UNITED STATES
NUCLEAR REGULATORY COMMISSION
REGION V
SUITE 202, WALNUT CREEK PLAZA
1990 N. CALIFORNIA BOULEVARD
WALNUT CREEK, CALIFORNIA 94596

License No. 04-17679-01E

Suncrux, Incorporated
10440 North Tantau Avenue
Cupertino, California 95014

MODULE TO CASE
ASSEMBLY,
TRITIUM

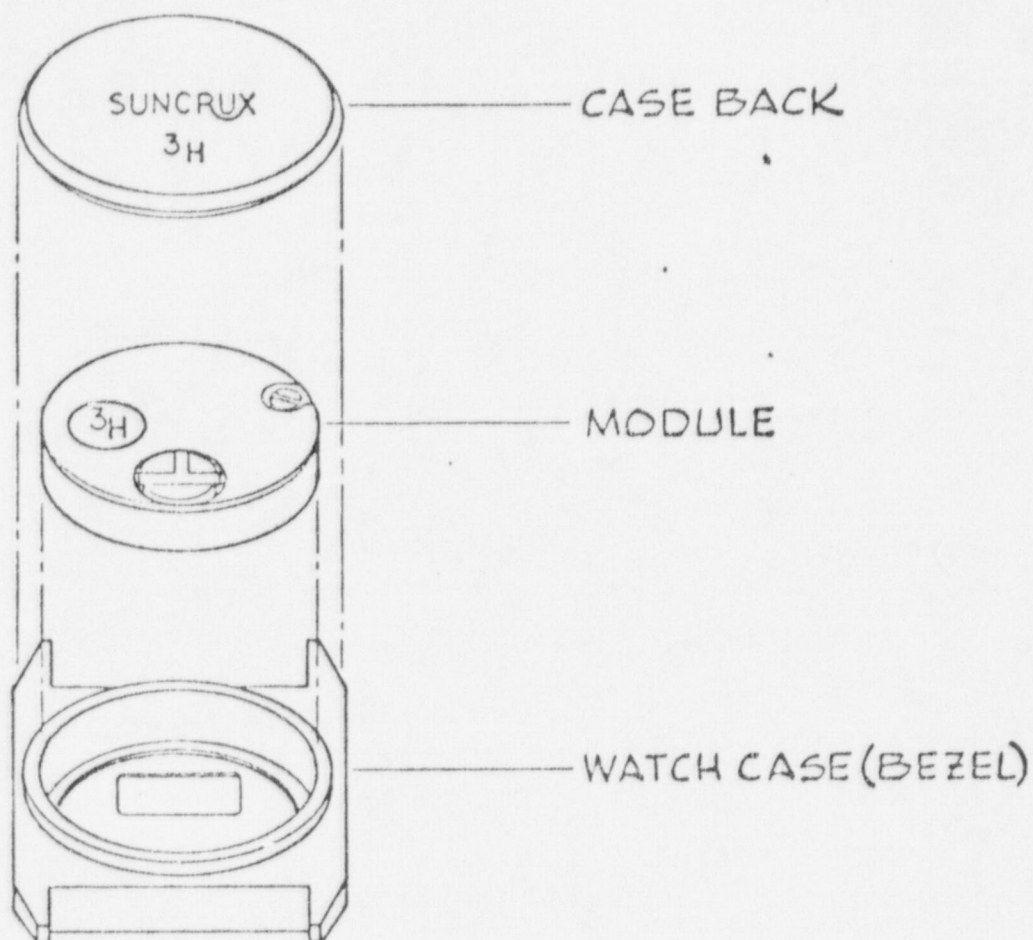
Your reply to Item C of the Notice of Violation did not state that watch markings to identify the presence of tritium and to indicate Suncrux as the manufacturer would be as shown in Drawing SK10777, included with the application dated October 6, 1977. (A copy of the drawing is enclosed for your convenience.) Please note that if the markings proposed in your letter differ from those in Drawing SK10777, you may need to amend your license to authorize the change.
